Invitation for Bid

IFB-4835-20-DH

Grand Junction Public Safety Facilities Renovation (Re-Bid)

AD1-1

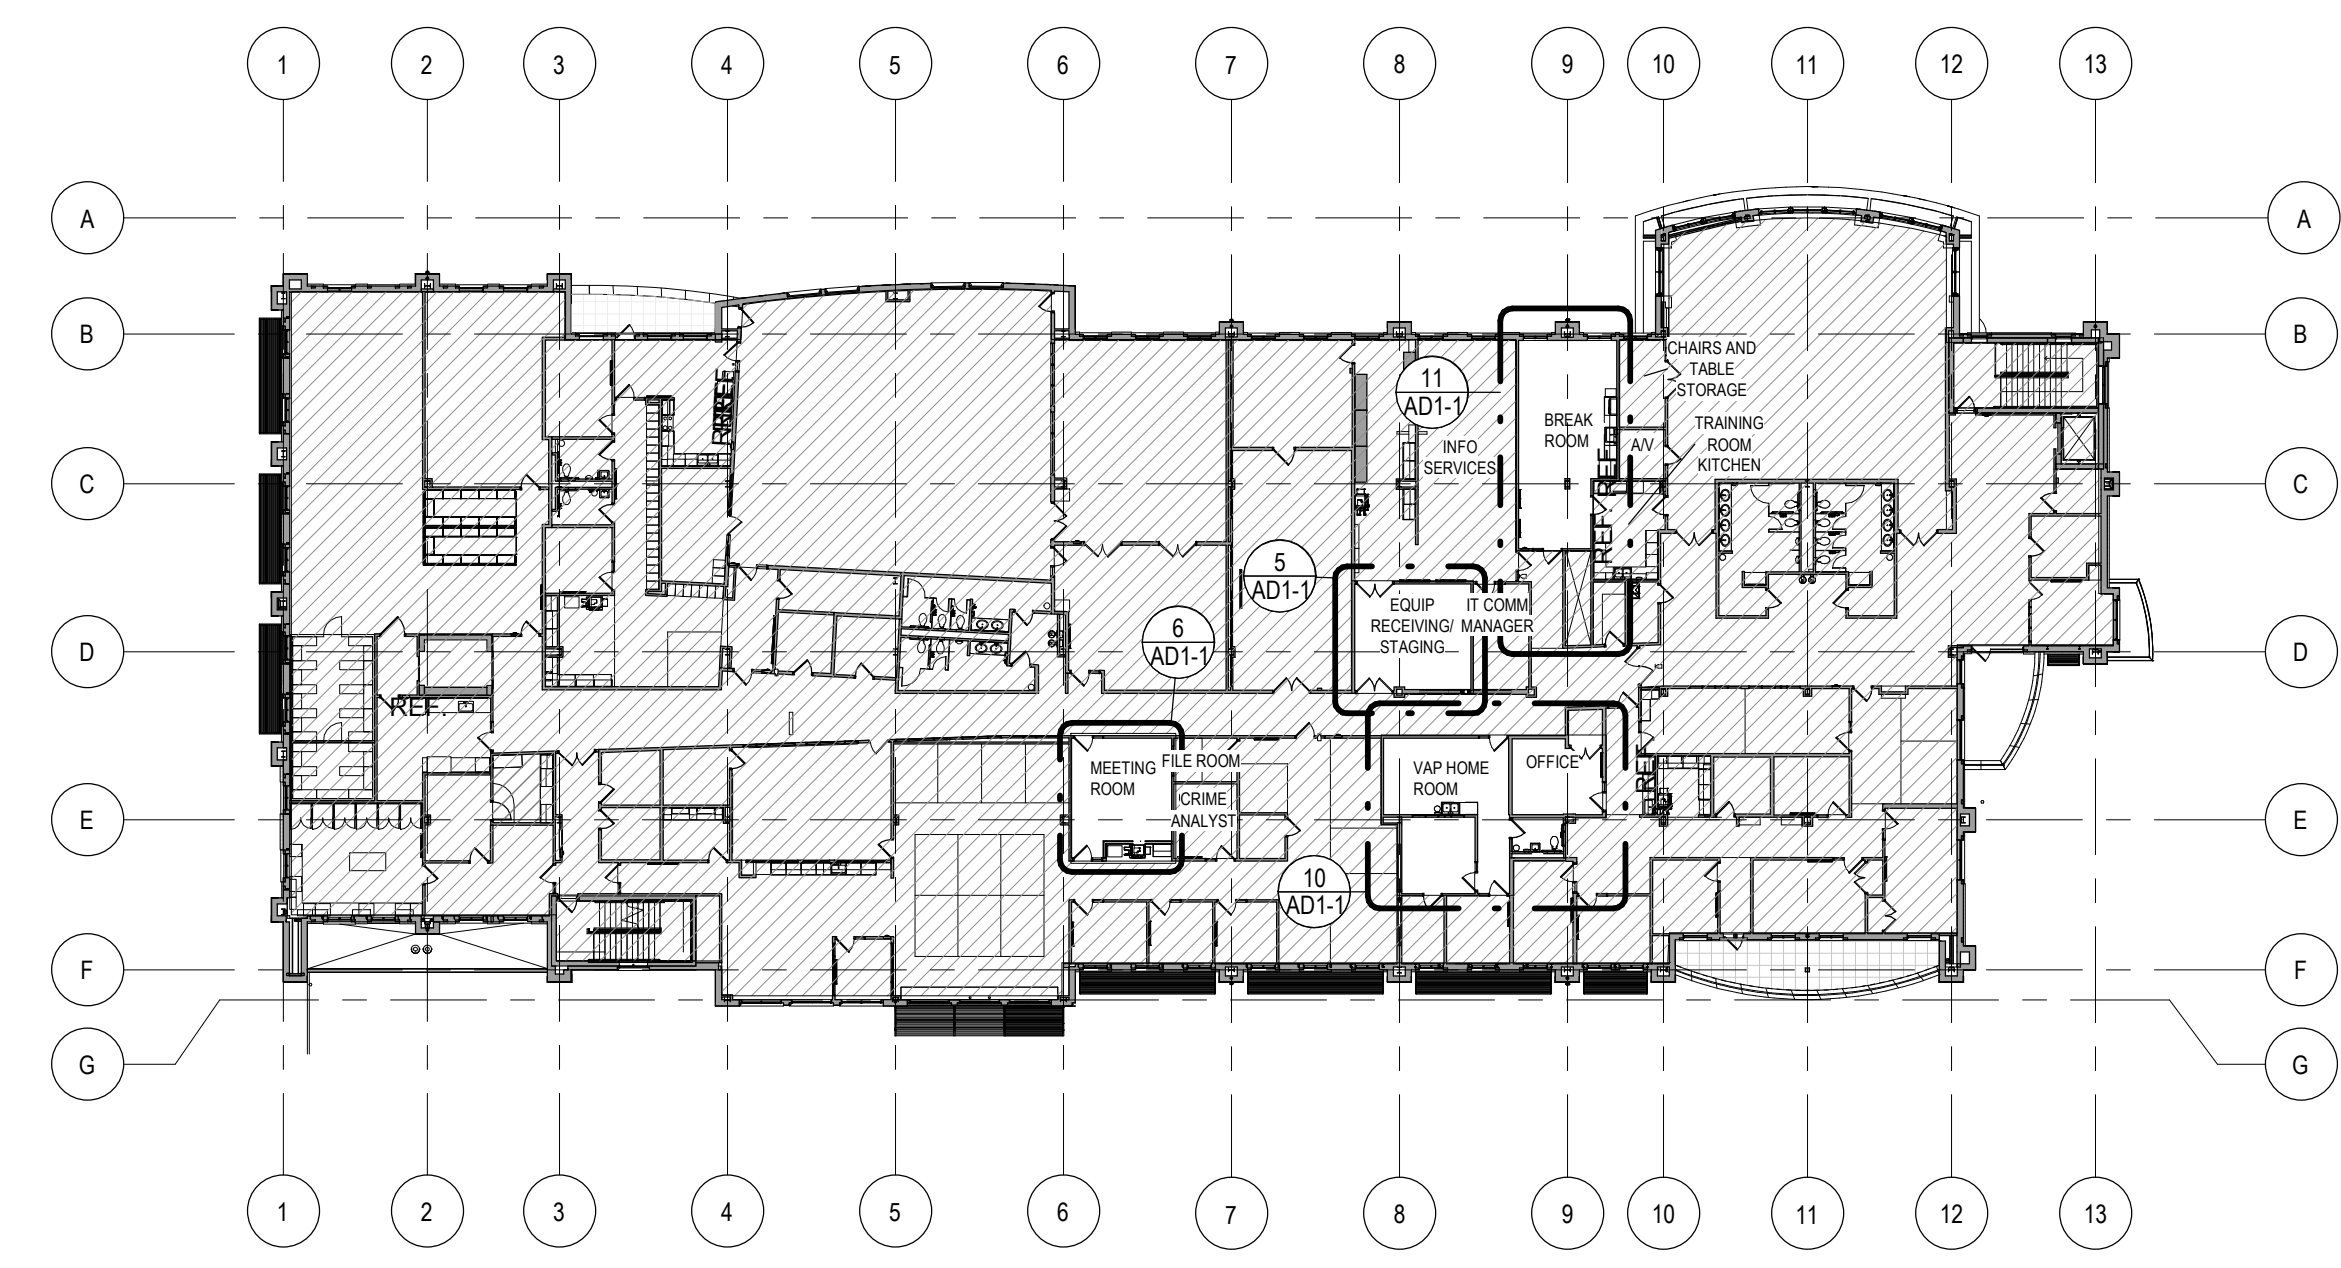
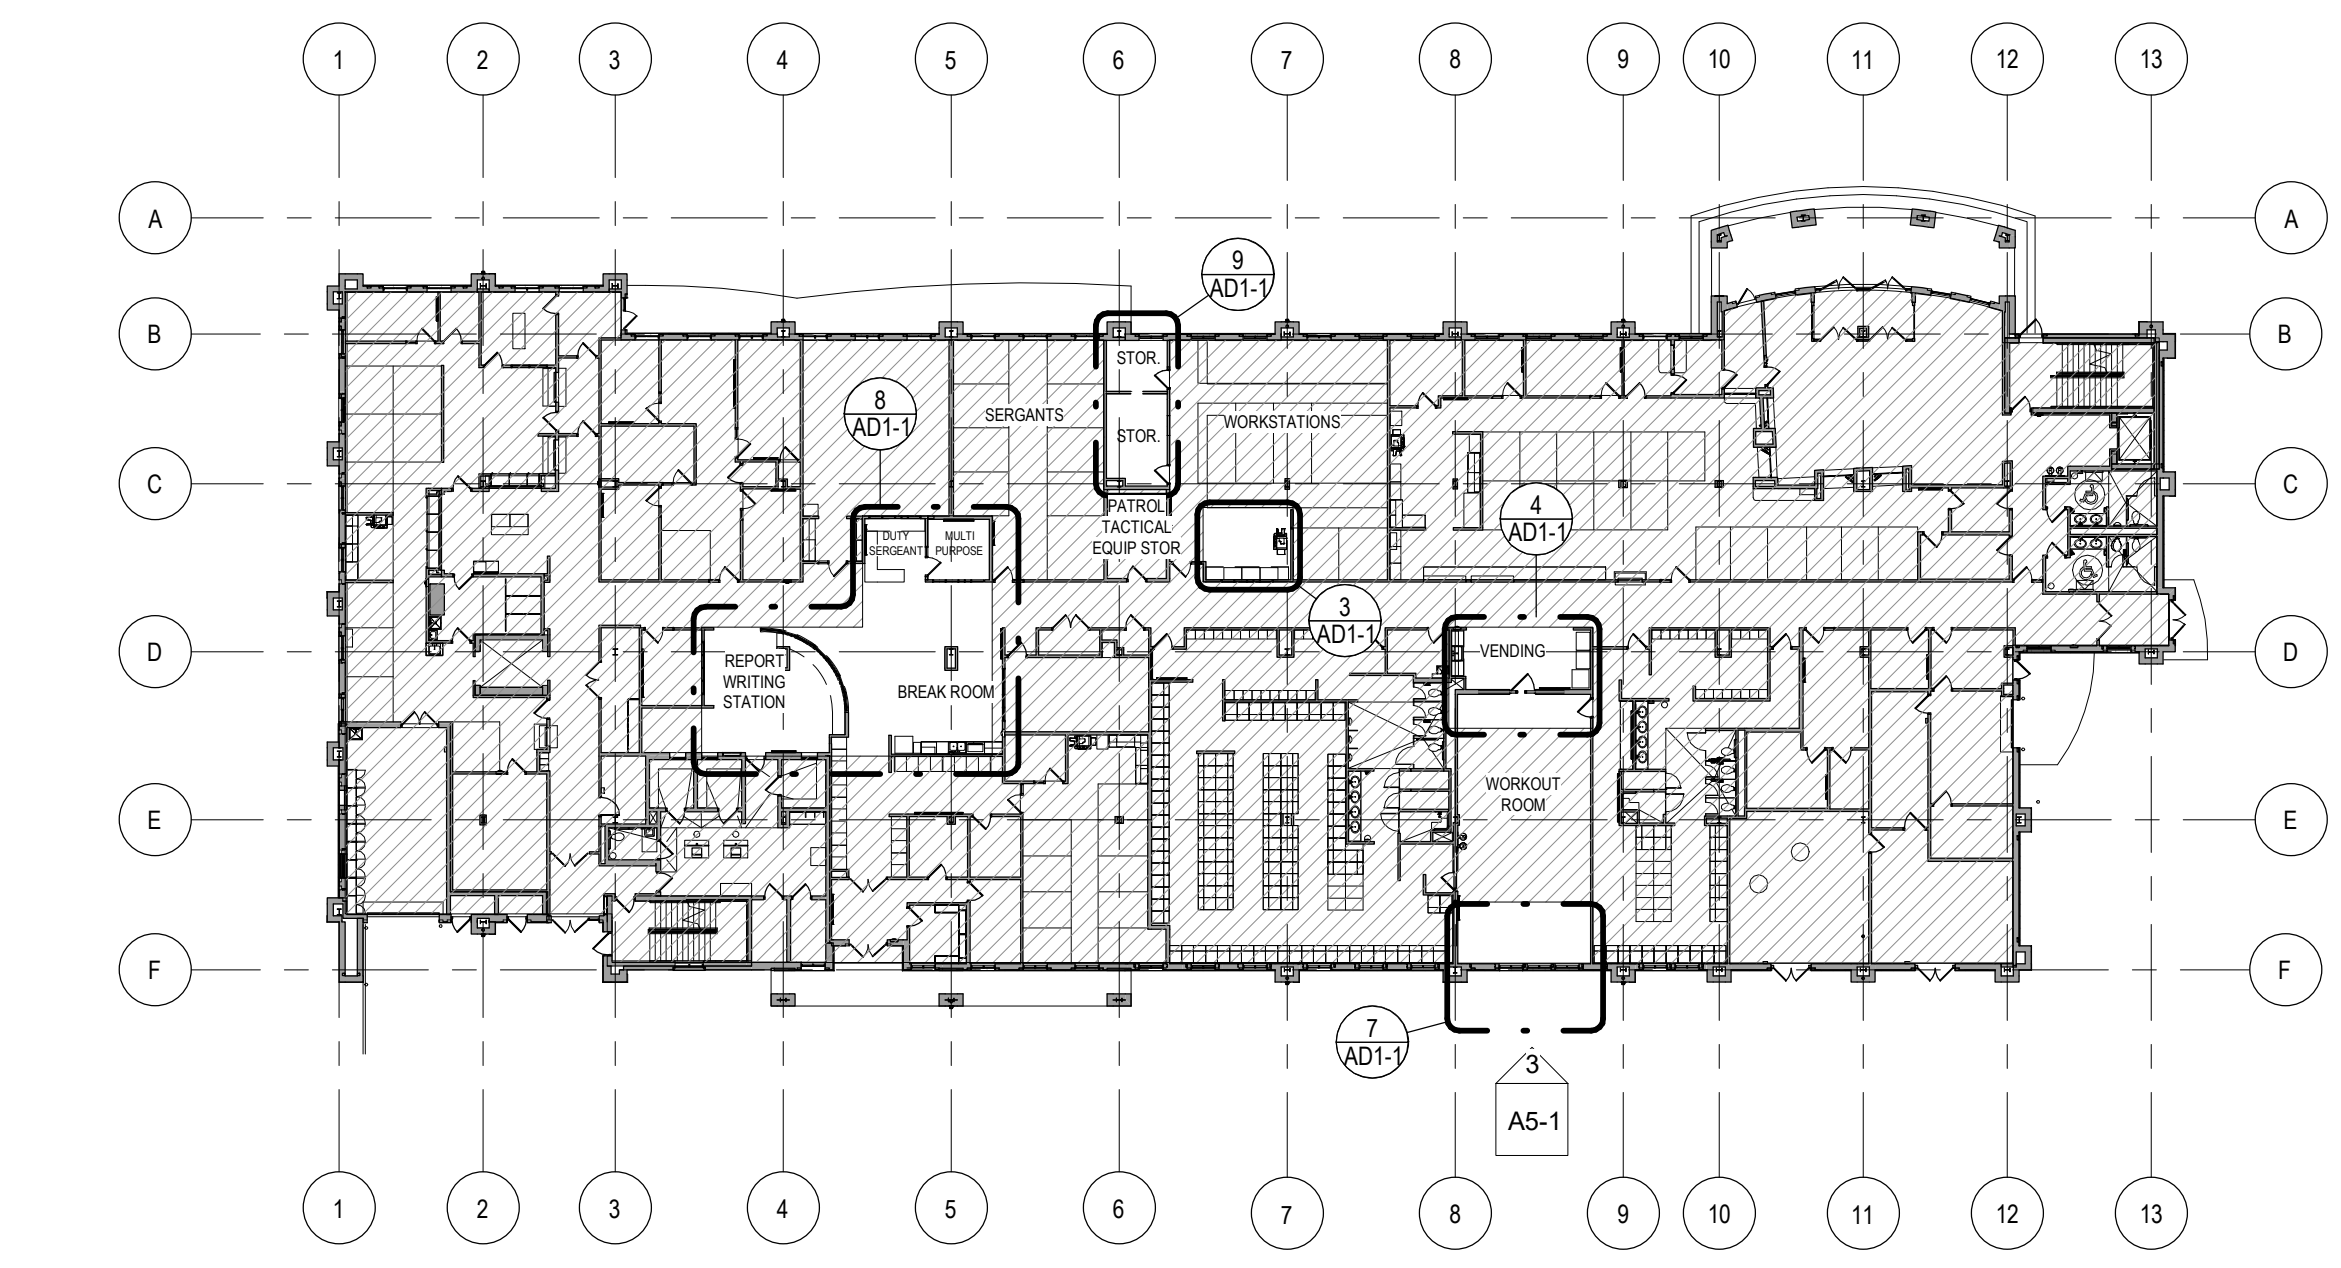
- A.** For correction/clarification, the Owner shall provide the access badges to the Contractor for this project.
- E. Q.** Sheet AD1-1 Keynote D7 says “Remove existing equipment, coordinate with owner for storage or disposal.” It was discussed at the Prebid meeting that the owner may remove these items prior to construction. Please clarify if it is the contractor’s responsibility or the owner’s responsibility to remove these items. If it is the contractor’s responsibility where will these items be stored? If the equipment is to be disposed of can you please provide us an equipment list so that we can calculate e-waste fees?

- A.** The City shall be responsible for removing these items.
- F. Q.** Sheet AD1-1 Keynote D13 says “Remove existing vending machines, coordinate with owner for storage or disposal.” It was discussed at the Prebid meeting that the owner may remove these items. Please clarify if it is the contractor’s responsibility or the owner’s responsibility to remove these items. If it is the contractor’s responsibility where will these items be stored.

- A.** See clarification listed in Item T of this section.
- G. Q.** Sheet AD1-1 Keynote D24 says “Remove existing bench, coordinate with owner for storage or disposal.” It was discussed at the Prebid meeting that the owner may remove these items. Please clarify if it is the contractor’s responsibility or the owner’s

responsibility to remove these items. If it is the contractor's responsibility where will these items be stored?

H. Q. Sheet AD1-1 Keynote D42 says "Remove existing Refrigerator, coordinate with owner for storage or disposal." It was discussed at the Prebid meeting that the owner may remove these items. Please clarify if it is the contractor's responsibility or the owner's responsibility to remove these items. If it is the contractor's responsibility where will these items be stored?

O. Q. Sheet AD1-1 detail 5 Key note 02-5 shows an existing structural frame in a wall where a new door is to be located. Please provide a detail of what will need to be done at this location to maintain structural integrity. If a detail cannot be provided what work should the contractor anticipate at this location for apples to apples bidding purposes.

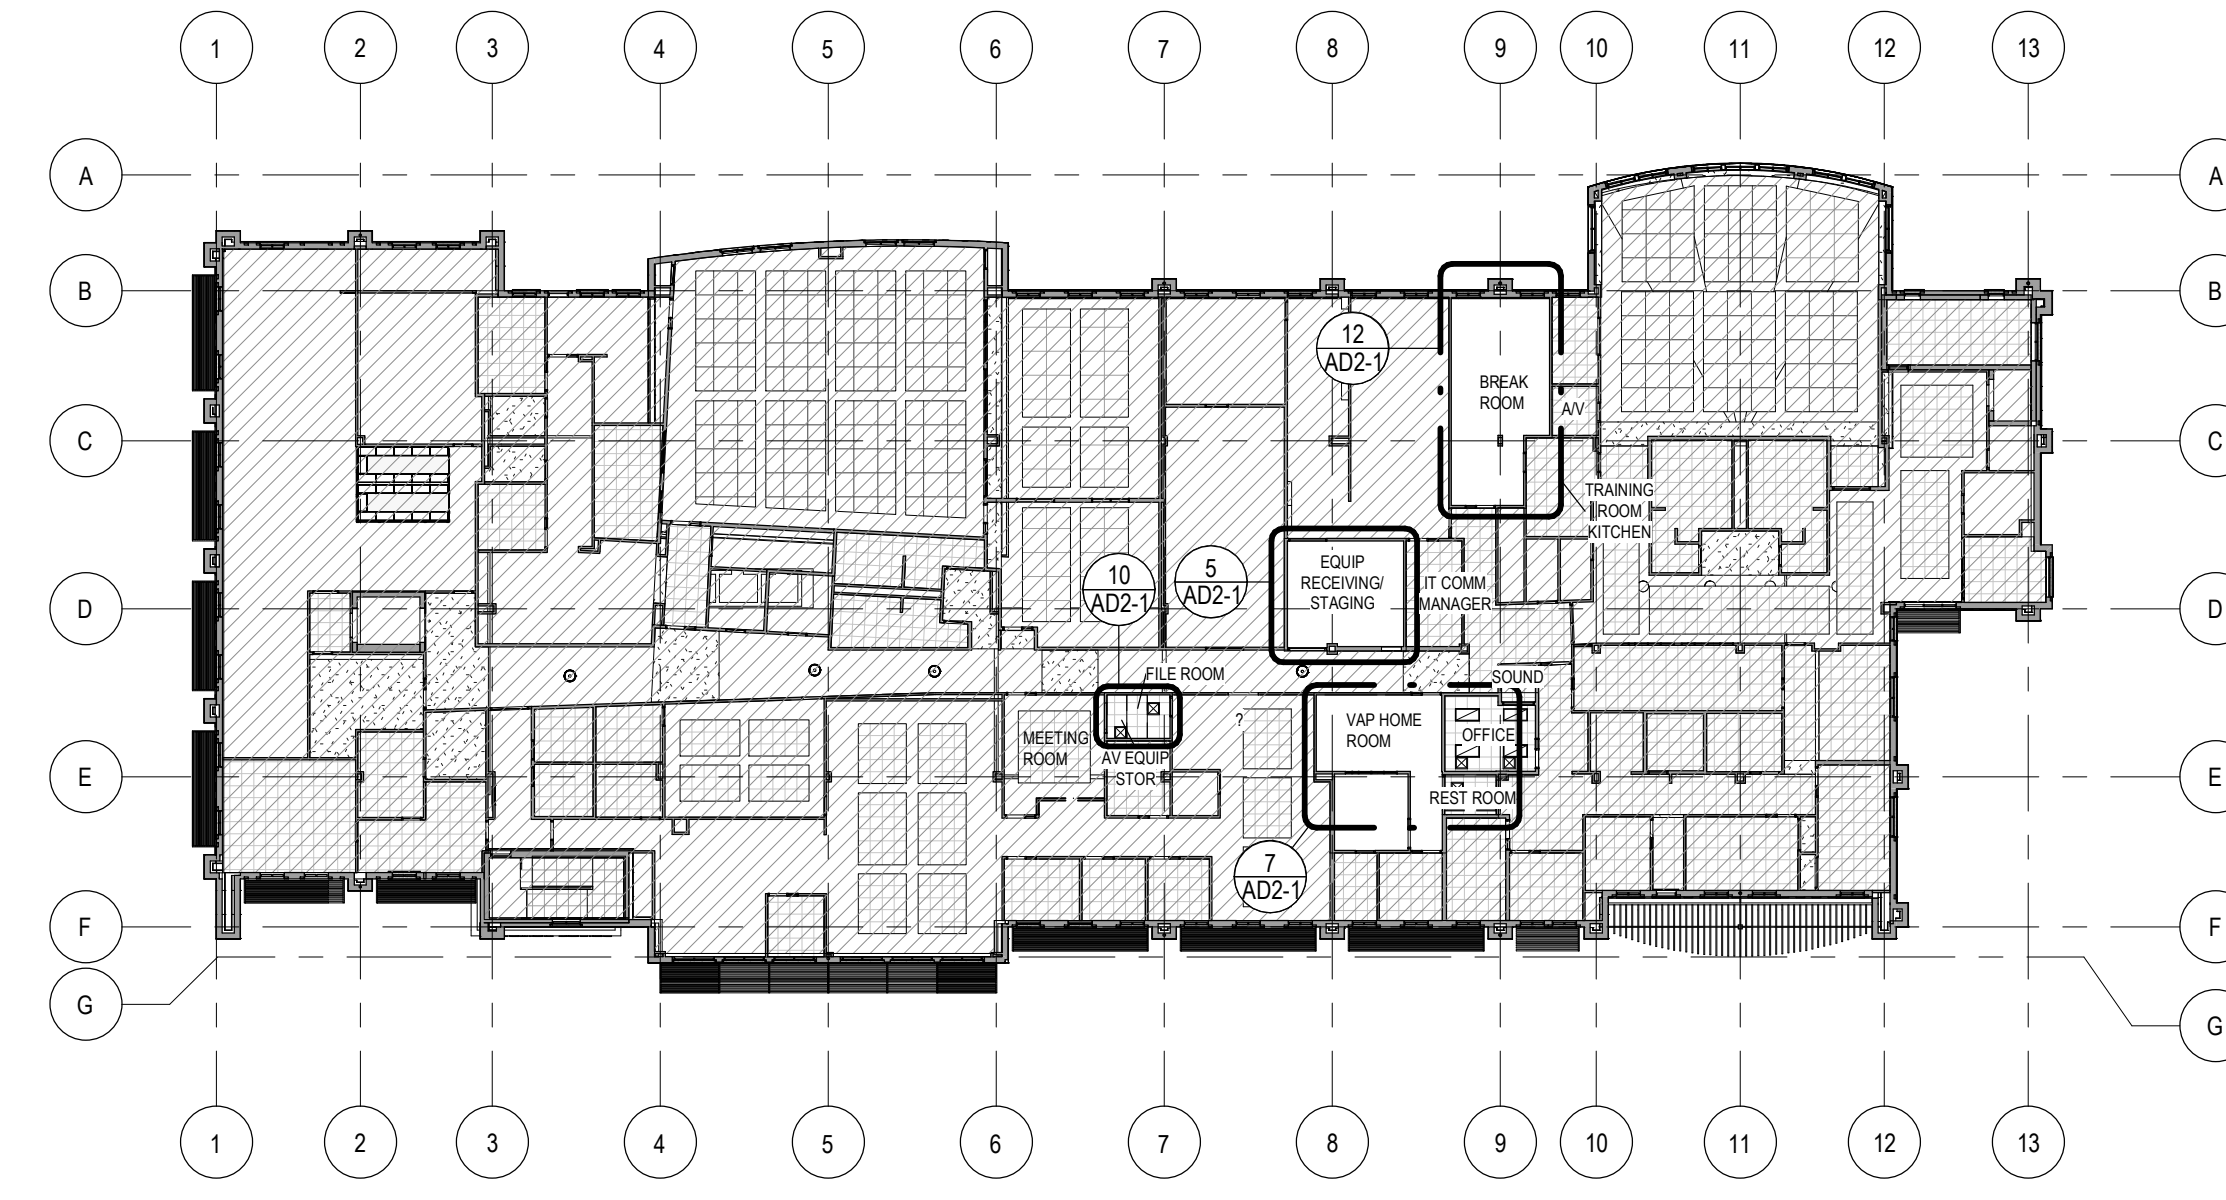
I. Q. Sheet AD2-1 Keynote D7 says "Remove existing free-standing shelving, coordinate with owner for storage or disposal." It was discussed at the Prebid meeting that the owner may remove these items. Please clarify if it is the contractor's responsibility or the owner's responsibility to remove these items. If it is the contractor's responsibility where will these items be stored?
